NOT AN "APPLES TO APPLES" CONVERSION OF THE EXISTING PUD

PROPOSED PUD-G 21

CURRENT PUD-8

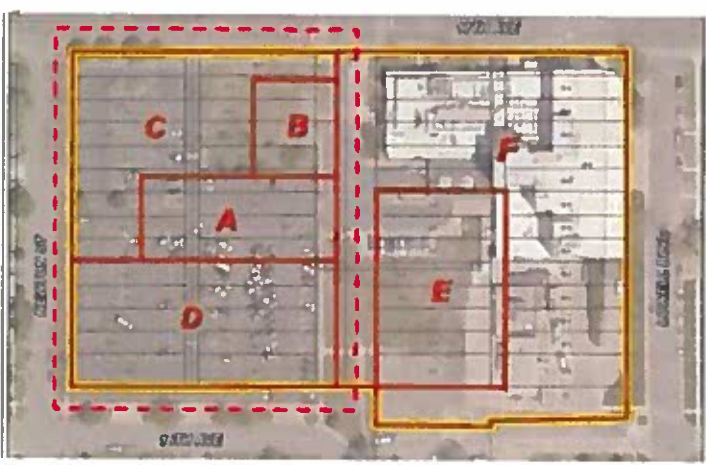
Such claims are categorically false. The existing PUD defines 515,400 sq. ft. of "maximum gross floor area above grade", and not "usable square feet". DZC 13.3-11 defines Gross Floor Area as "The sum of the gross horizontal areas of the several floors of a Completely Enclosed Structure.." DZC does not define "usable square feet", nor does the PUD-G 21 application define gross floor area, but it can be estimated from the square footage and floor count defined for each sub area. By this formal definition, and not counting parking, the proposed buildings in the north parking lot would be **2.5x larger than what is allowed by current zoning**.

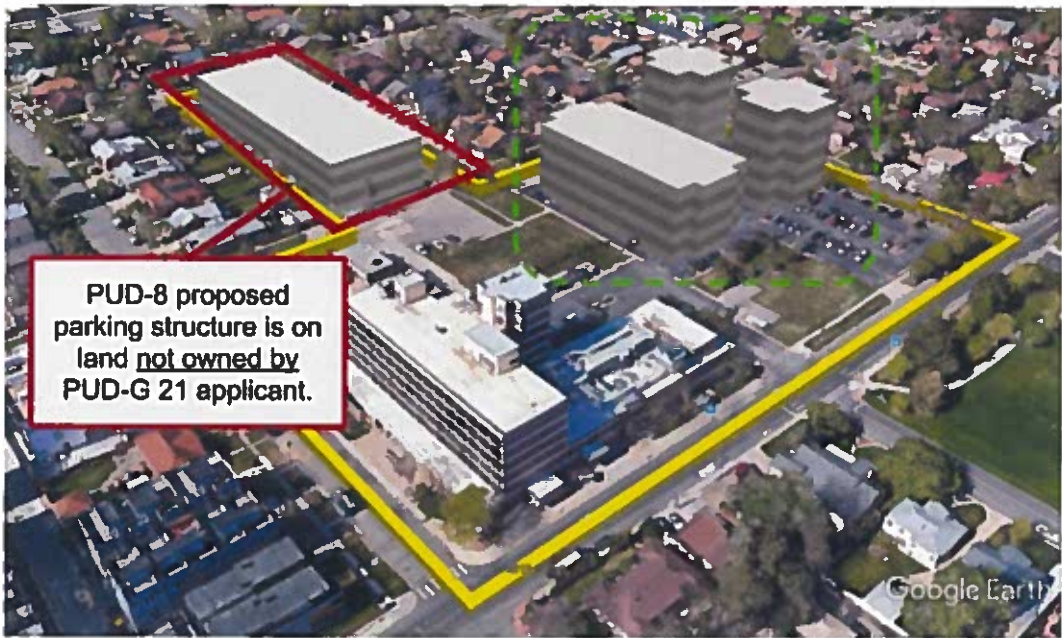
Not only is the massing of the proposed development is significantly larger than what is allowed under the current zoning, but the proposal has none of the open space and setbacks that were defined in the original PUD. Furthermore, the developer has asked for variances to reduce normal DZC setback requirements.

The proposed building scale and massing is inconsistent with the neighborhood context, and the requested setback and height variances will provide result in even more non-conformance with normal zoning standards.
